PUBLIC INTEREST REVIEW FOR GROUNDWATER APPLICATIONS

SUBJECT: Application G- 17953 Supersedes review of \_\_\_\_\_  
Date of Review(s)

**A. GENERAL INFORMATION:** Applicant's Name: Salem Nursery LLC County: Marion

A1. Applicant(s) seek(s) 0.30 cfs from 1 well(s) in the Willamette Basin,  
Mill Cr. - Pudding R. subbasin Quad Map: Woodburn

Figure 1: Application Review Map

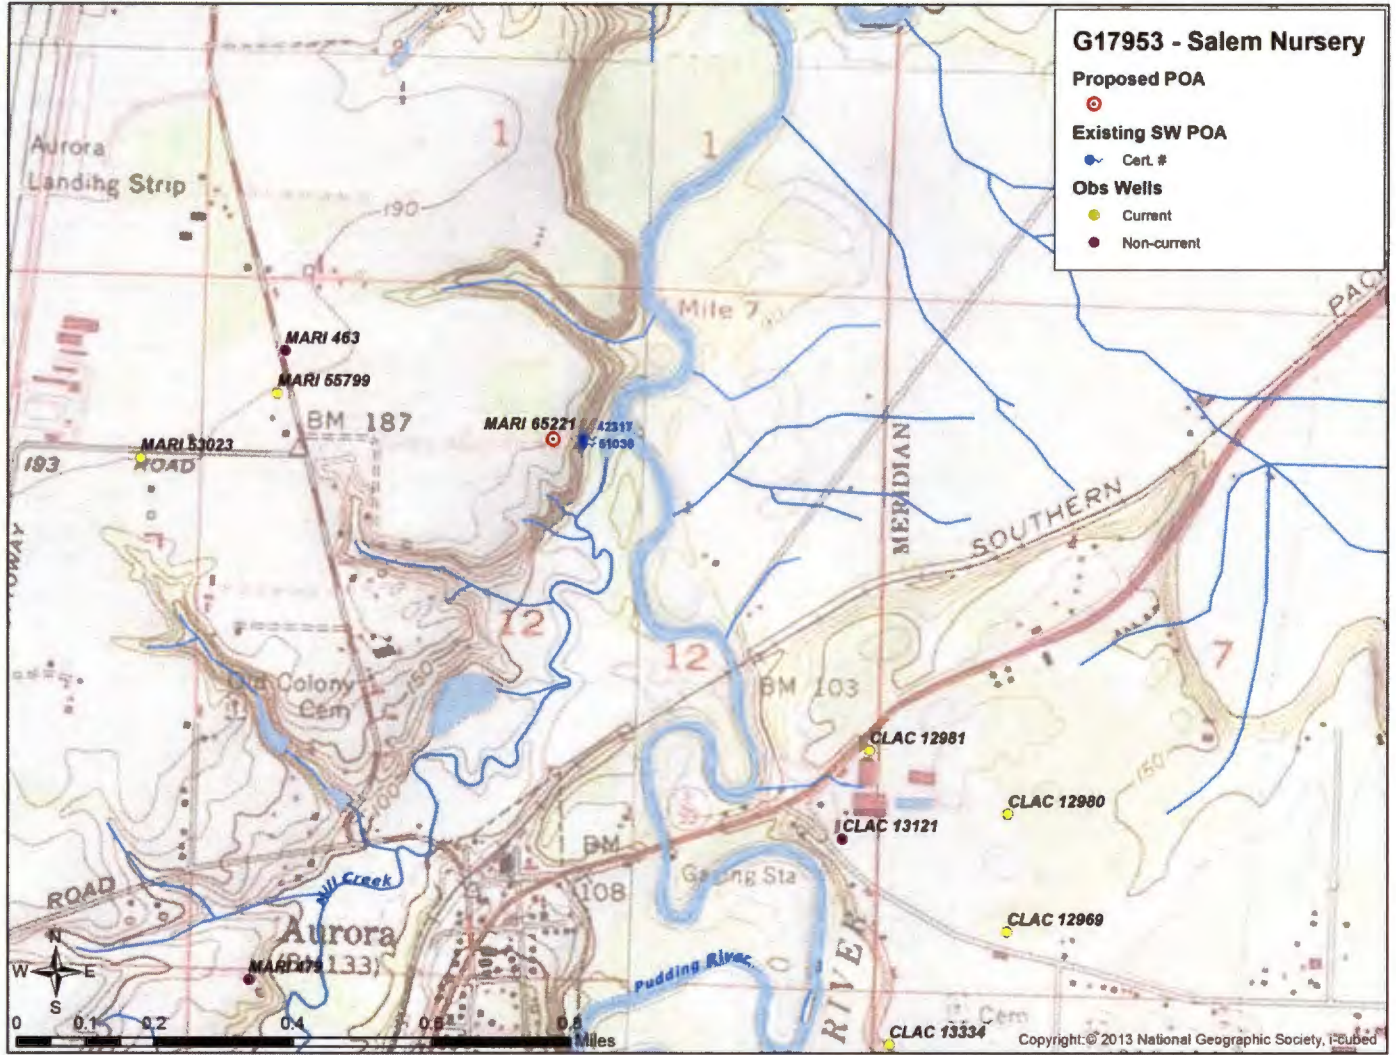
B3. **Groundwater availability remarks:** The applicants well (MARI 65221 – well log attached) is located on a bench above the Pudding River (Figure 1) that is made up of low-permeability silt and clay (Willamette Silt Unit) from land surface to approximately 100 ft. Below these fine-grained sediments are approximately 100 ft of more-permeable sands, gravels, and silts (Willamette Aquifer) which themselves overlie more clay. The applicants well is open to and produces from the permeable coarse sediments between 100 and 200 ft bls according to the well log. Although overlain by clayey material the coarse-grained aquifer does not appear to be confined based on comparison between water bearing zone and static water level, likely due the its proximity to the edge of the bench and Pudding River (the likely discharge source) which cuts through much of the upper clay unit and possibly into the coarse-grained alluvium underneath (Conlon et al., 2005).

Figure 2: Water level data from nearby wells; all wells are within one 1 mi<sup>2</sup> section surrounding proposed POA

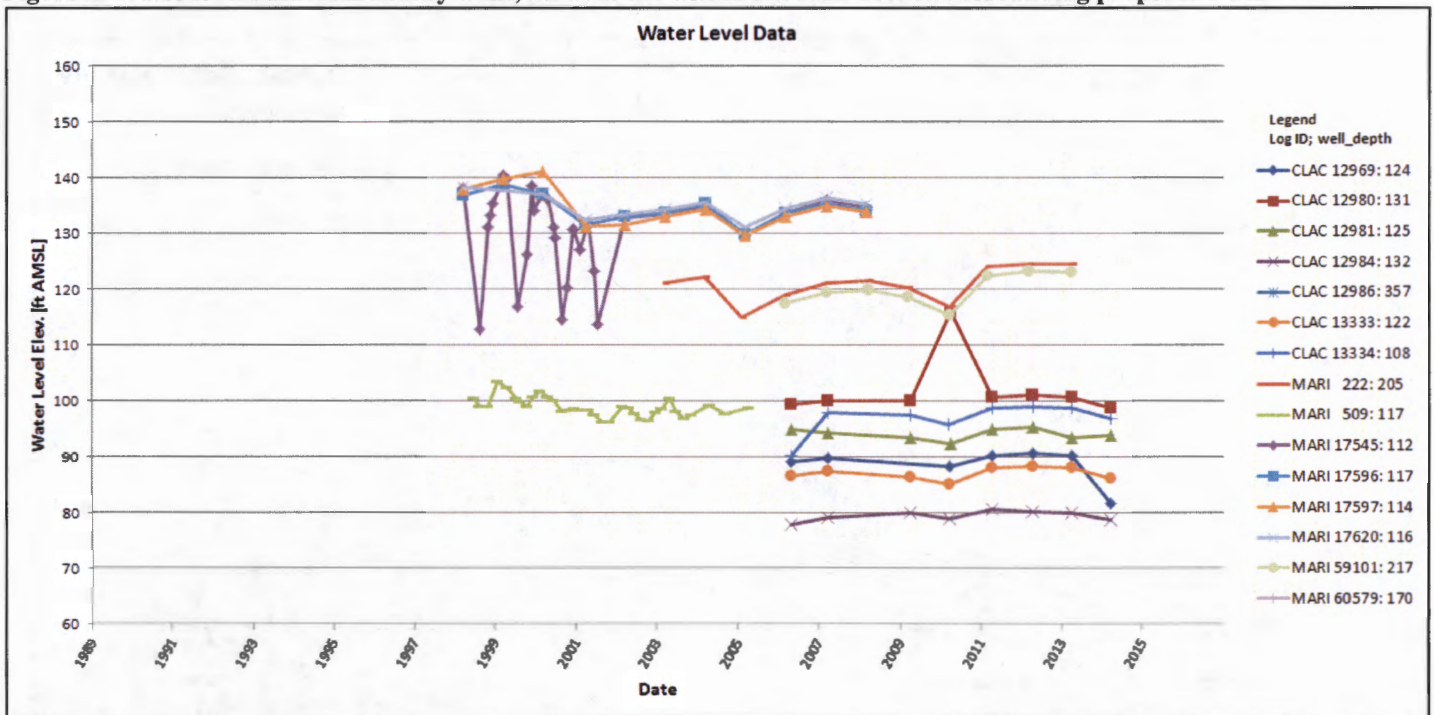
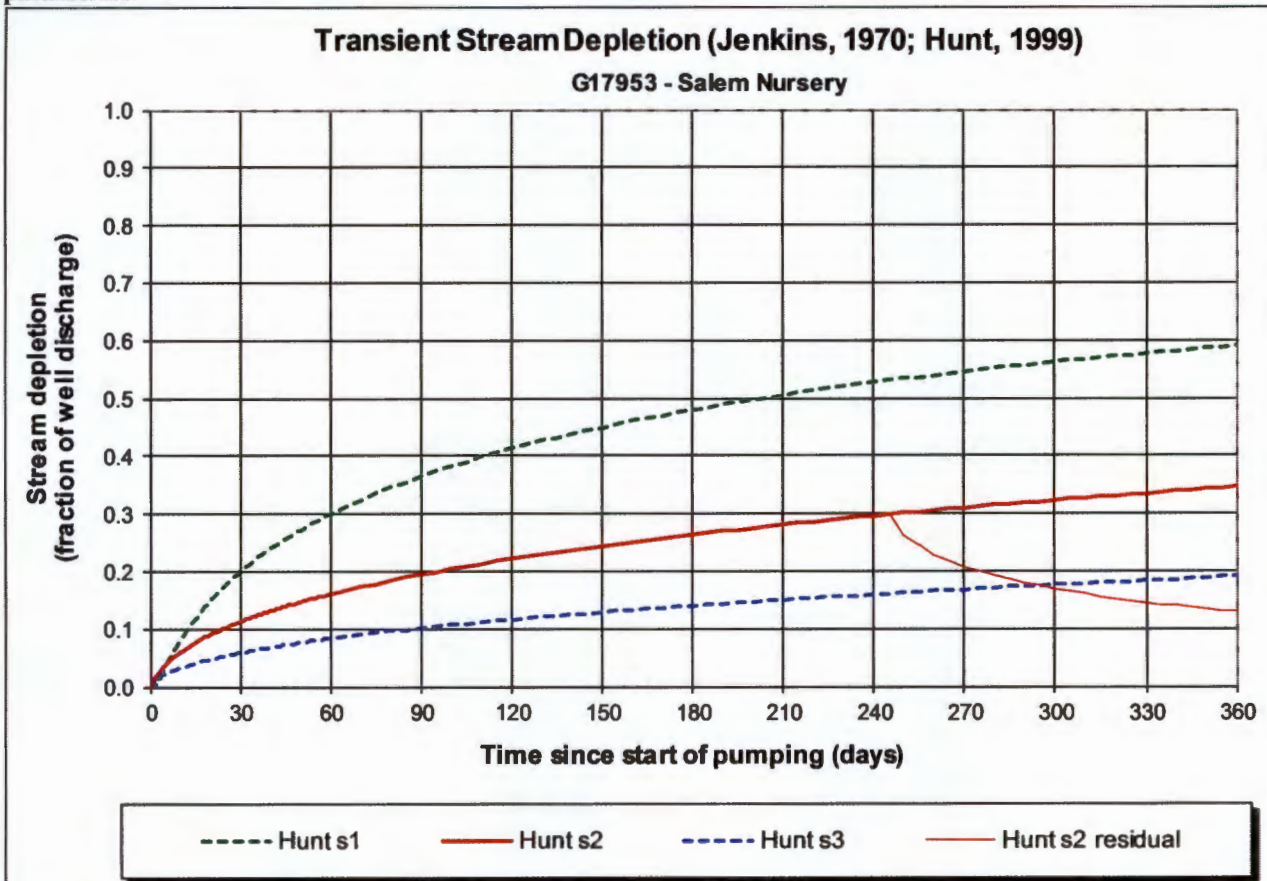
Water level data from wells in the area of the applicant’s well (Figure 2) show stable water levels over time, which suggests groundwater is not over-appropriated at this time.
